**THE DELAVAL PROPERTY  
ENVIRONMENTAL RESTORATION PROGRAM PROJECT**

**Addendum No. 4**

**September 26, 2007**

**Sketches SK-1 & SK-2**

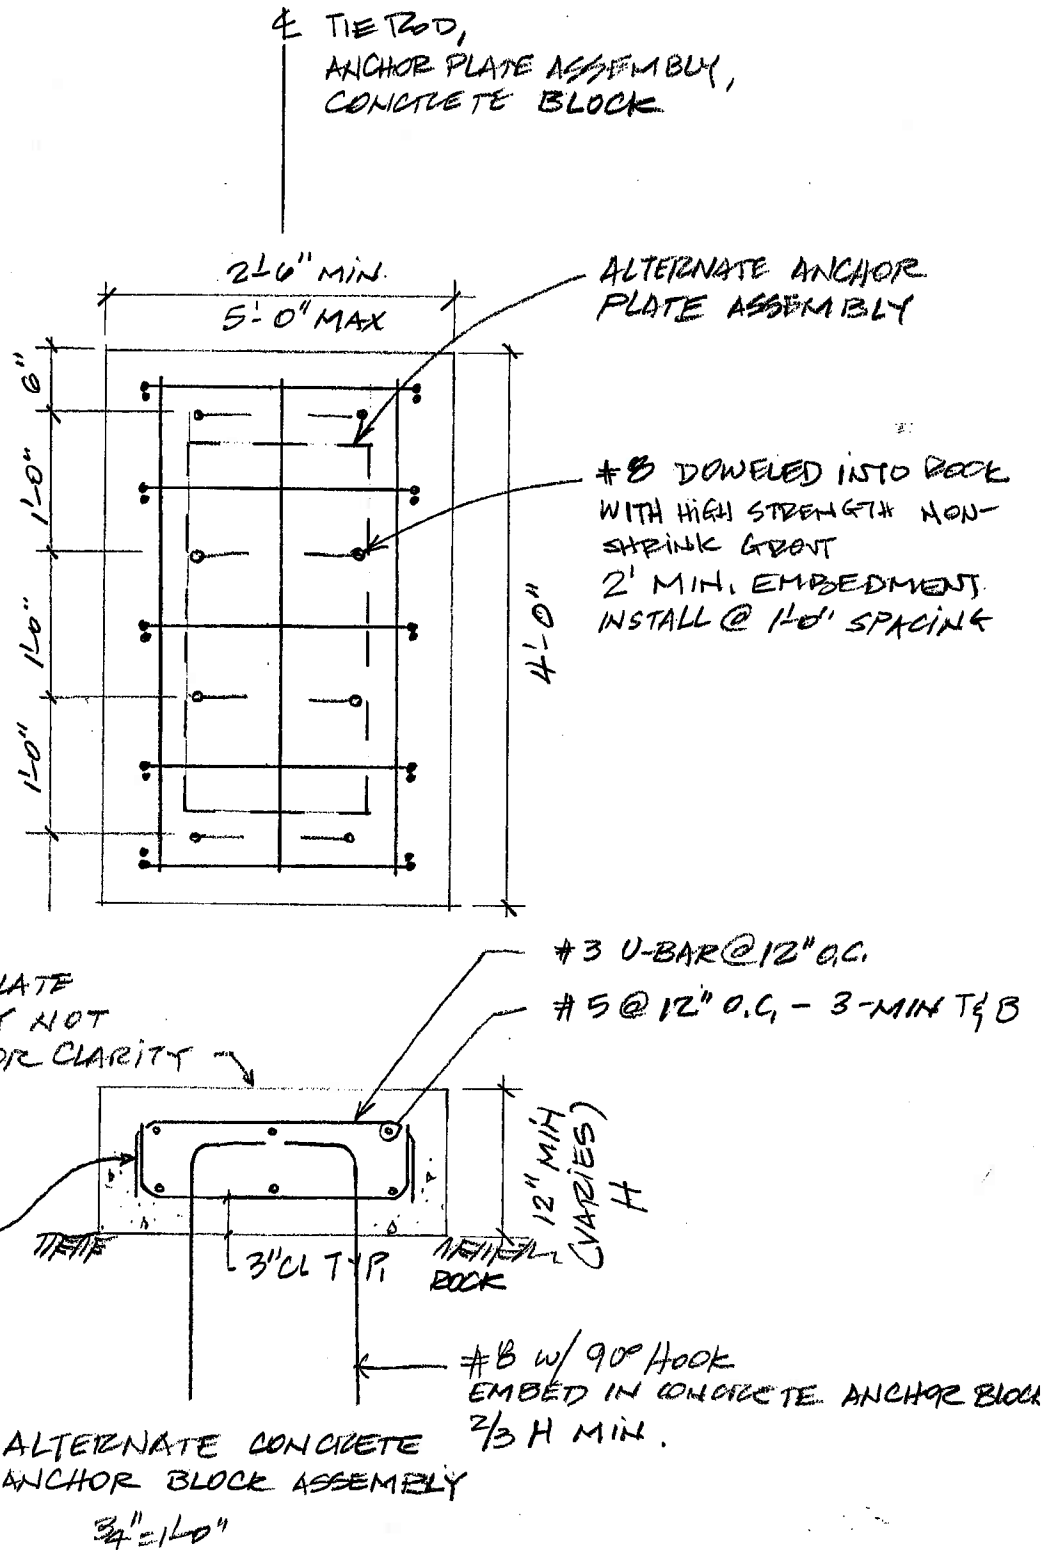
2. ADD Sketches SK-1 and SK-2, included in Attachment B, as prepared by Ocean & Coastal Consultants Engineering, P.C., and dated September 24, 2007.

### CONCRETE BLOCK SIZE + DOWELS.

HEIGHT OF BLOCK	DOWELS REQUIRED	SIZE OF CONG BLOCK	TOTAL # DOWELS	DOWEL HOOK	DOWEL EMBED
10'	5 DOWELS PER ROW	4' x 5'	20	90°	24"
8'	4 DOWELS PER ROW	4' x 4'	16	90°	24"
6'	3 DOWELS PER ROW	4' x 3'	12	90°	24"
4'	3 DOWELS PER ROW	4' x 3'	12	90°	24"
2' AND UNDER	2 DOWELS PER ROW	4' x 2.5'	8	90°	24"

- NOTES:
- 1- REINFORCEMENT SHALL BE EPOXY-COATED
  - 2- DOWEL EMBEDMENT IN ROCK SHALL BE AT LEAST  $\frac{2}{3}$  OF HEIGHT OF BLOCK
  - 3- PROVIDE #5 @ 12" O.C. HORIZONTAL FACE REINFORCEMENT ATTACHED TO U-BARDS ON CONCRETE BLOCK 4' HIGH AND OVER.
  - 4- INSTALL ANCHOR PLATE ASSEMBLY SUCH THAT TIE ROD IS HORIZONTAL
